CITY OF NEWPORT BEACH PLANNING COMMISSION STAFF REPORT

December 7, 2017
Agenda Item No. 5

SUBJECT: Ginsberg Residence (PA2016-170)

SITE LOCATION: 2607 Ocean Boulevard

SECTION G-G

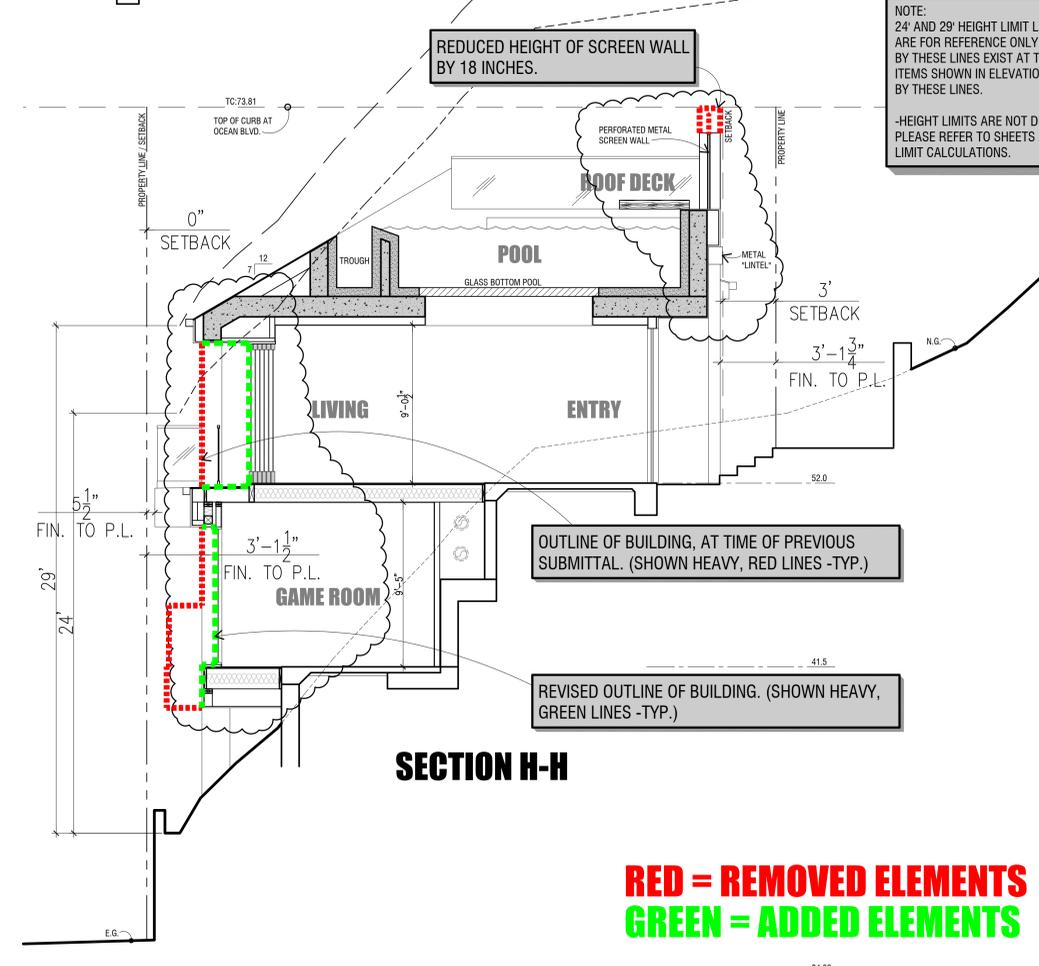
UPDATED CROSS-SECTIONS TO REFLECT CHANGES TO THE HEIGHT AND EXTERIOR ELEVATIONS OF PROPOSED HOME.

OUTLINE OF BUILDING, AT TIME OF PREVIOUS SUBMITTAL. (SHOWN HEAVY, RED LINES -TYP.)

REVISED OUTLINE OF BUILDING. (SHOWN HEAVY, GREEN LINES -TYP.)

SECTION H-H

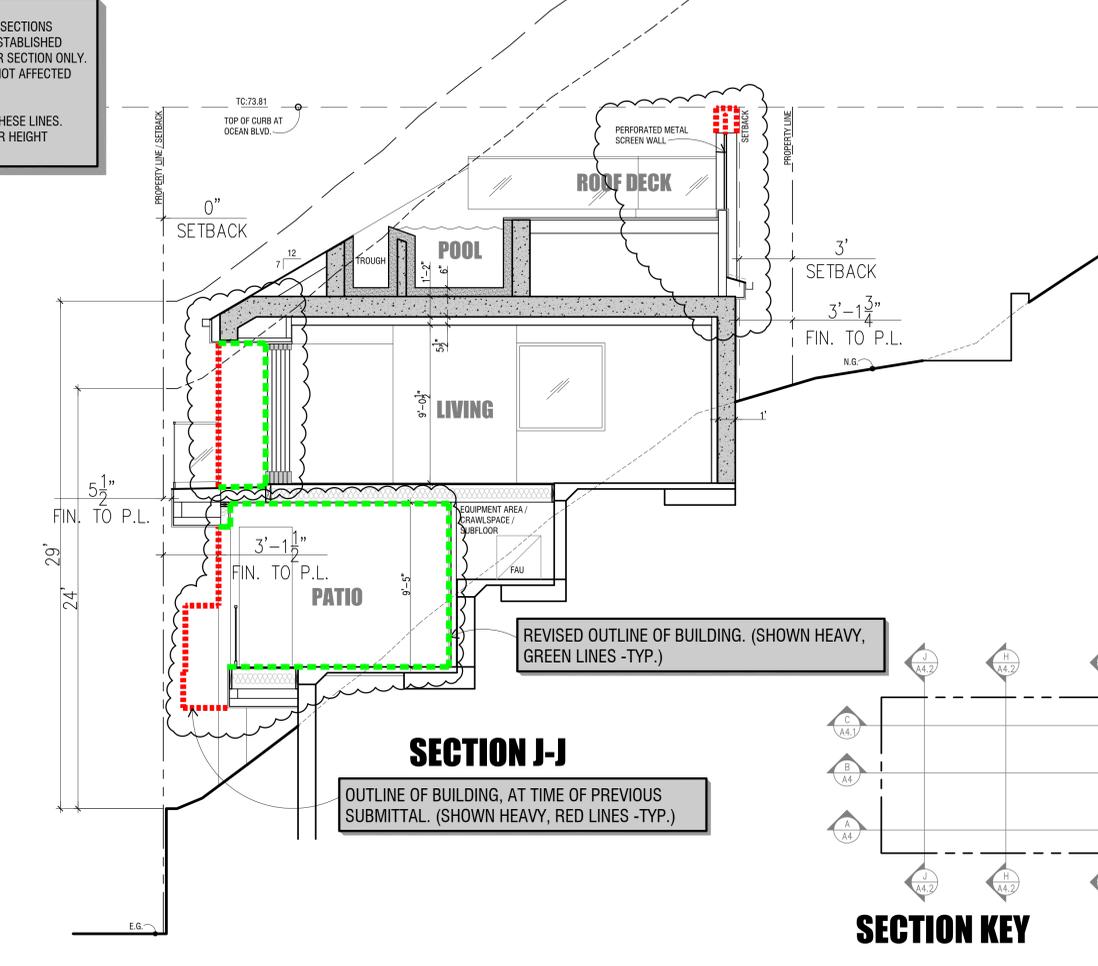
OUTLINE OF BUILDING, AT TIME OF PREVIOUS SUBMITTAL. (SHOWN HEAVY, RED LINES -TYP.)

REVISED OUTLINE OF BUILDING. (SHOWN HEAVY, GREEN LINES -TYP.)

SECTION J-J

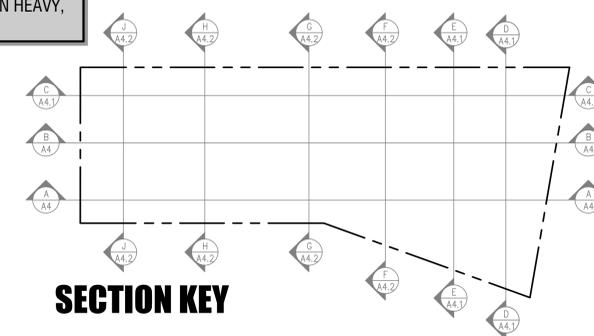
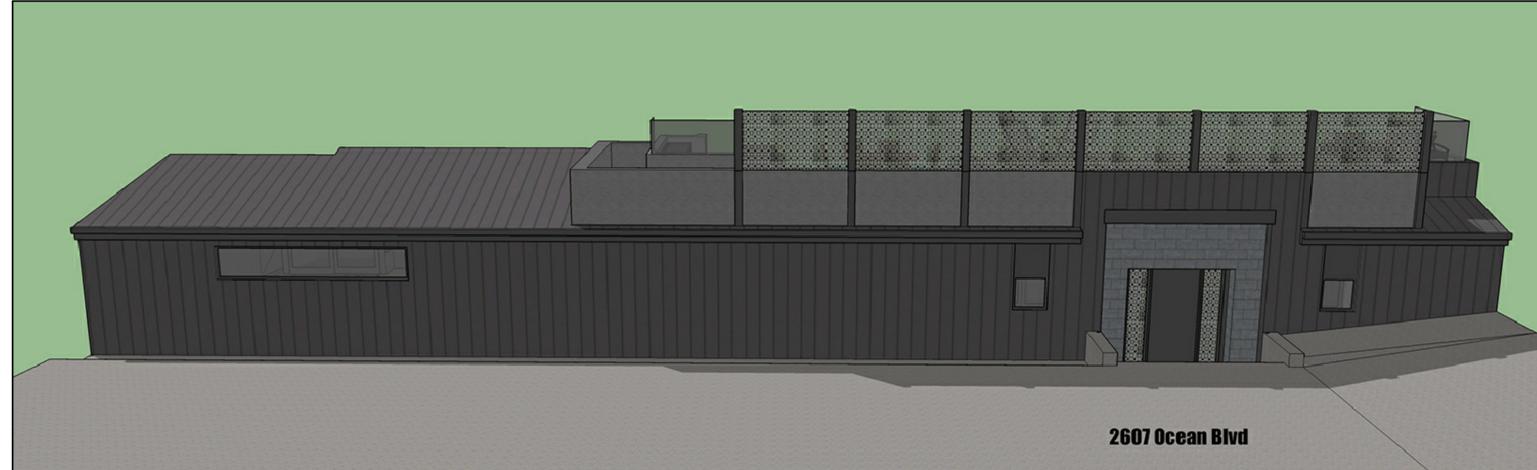
OUTLINE OF BUILDING, AT TIME OF PREVIOUS SUBMITTAL. (SHOWN HEAVY, RED LINES -TYP.)

REVISED OUTLINE OF BUILDING. (SHOWN HEAVY, GREEN LINES -TYP.)

REDUCED HEIGHT OF SCREEN WALL BY 18 INCHES.

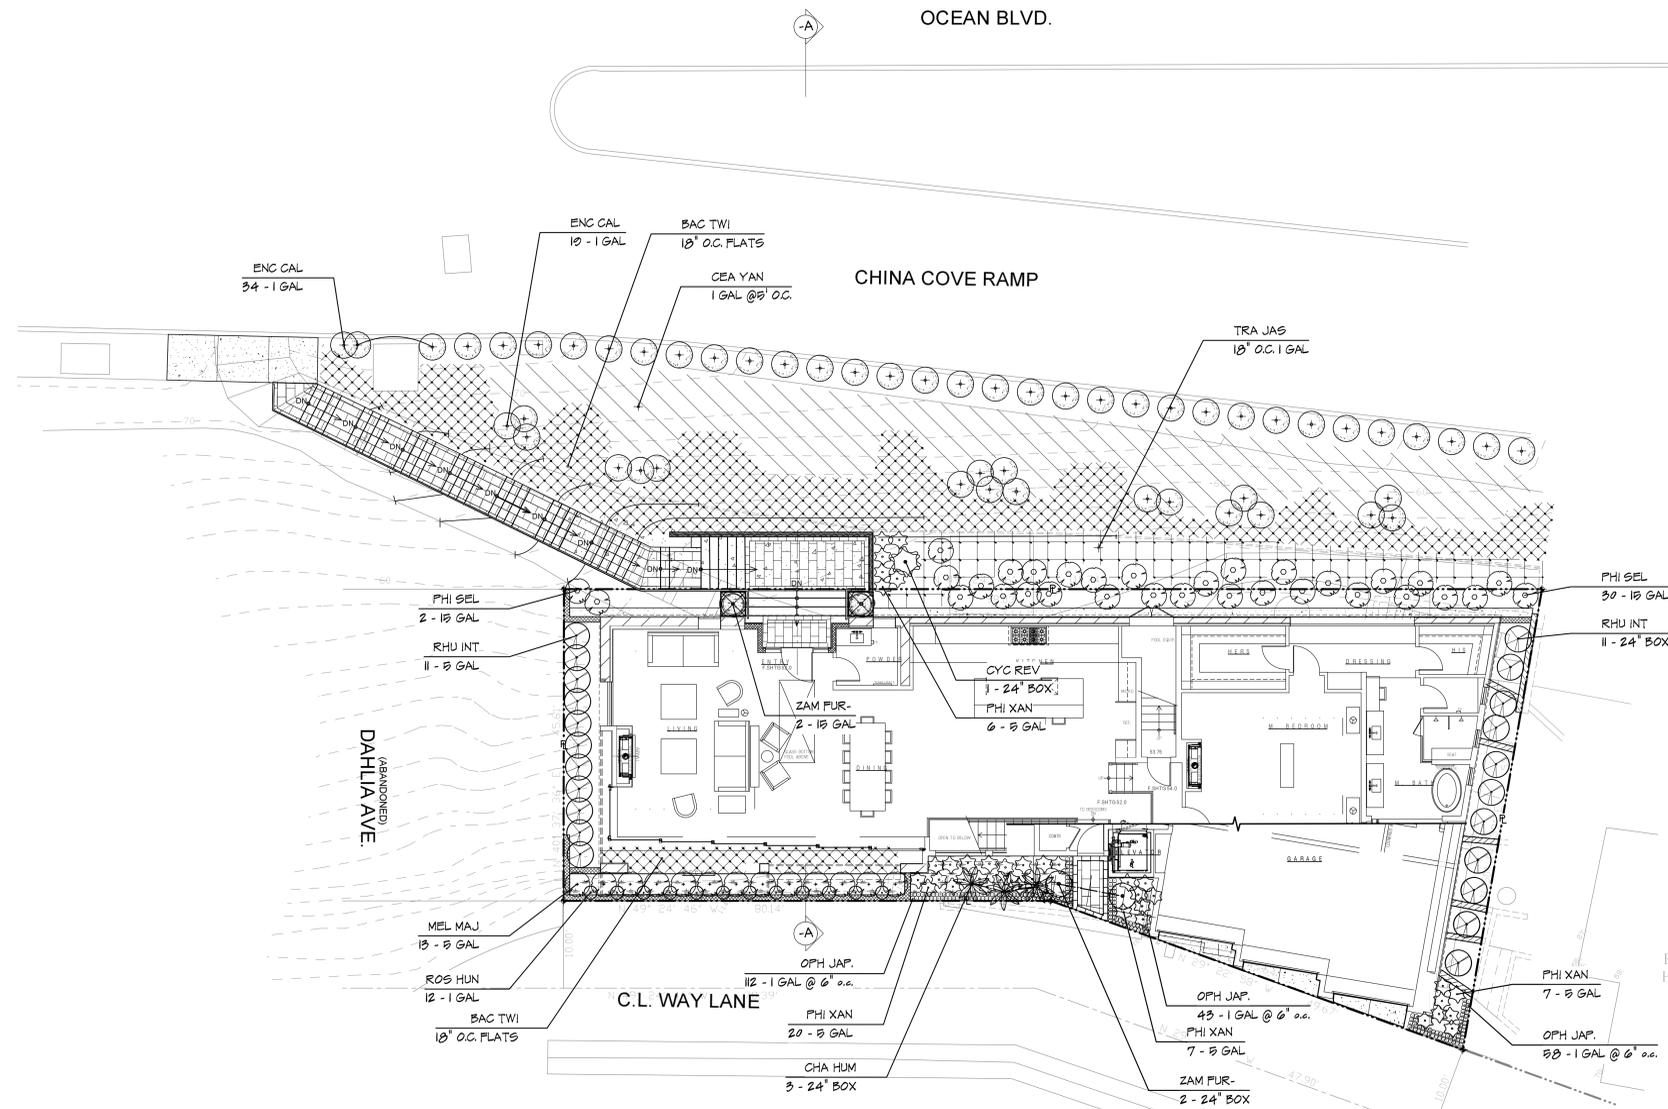
NOTE:
 UPDATED CROSS-SECTION TO REFLECT CHANGES TO THE HEIGHT AND EXTERIOR ELEVATIONS OF PROPOSED HOME

OUTLINE OF BUILDING, AT TIME OF PREVIOUS SUBMITTAL. (SHOWN HEAVY, RED LINES -TYP.)

REVISED OUTLINE OF BUILDING. (SHOWN HEAVY, GREEN LINES -TYP.)
